工程變更通知單(ECN)

No:ECN-201507001

變更機種(model change) : All 10.1" 1024*600 Hannstar LCD series model	變更機種(model change): All 10.1" 1024*600 Hannstar LCD series model -S, see model list below. 變更內容(change content): backlight metal modified to no open window
變更原因(change reasons): <input type="checkbox"/> 降低成本(cost down) <input type="checkbox"/> 製程需要(production process) <input type="checkbox"/> 規格變更(spec revised) <input type="checkbox"/> 更換材料(material change) <input type="checkbox"/> 工程問題改善 (engineering problem improved) <input type="checkbox"/> 客戶需求 (customer asked) <input checked="" type="checkbox"/> 其他(other) : Molding modified	變更原因(change reason): due to metal with open window, old backlight reflector film easy damaged caused optical failure . New backlight with metal covered all.

Metal Frame (Old)	Metal Frame (New)

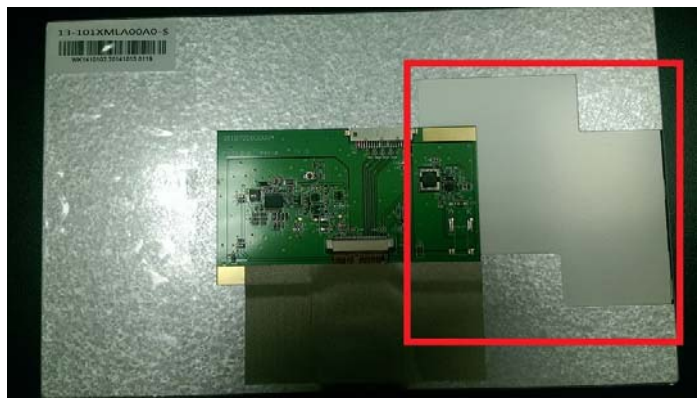
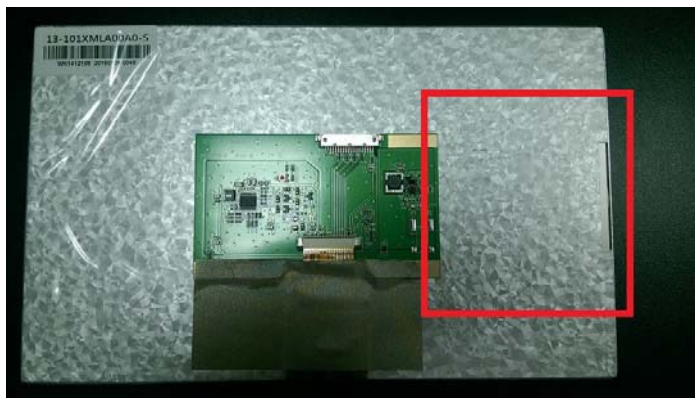
1. Appearance for Metal frame

- A. 原有下鐵有開口的模具已修改..所以後續供貨會改為無開口的下鐵. (Old metal frame has modified to New, so all the future shipment will change to new metal frame., Effected date from 2015/07/17.)
- B. 此修改對於機構..在尺寸上沒有變動..僅外觀有差異. (This modification no any effected for mechanical size, only appearance looks differences.)
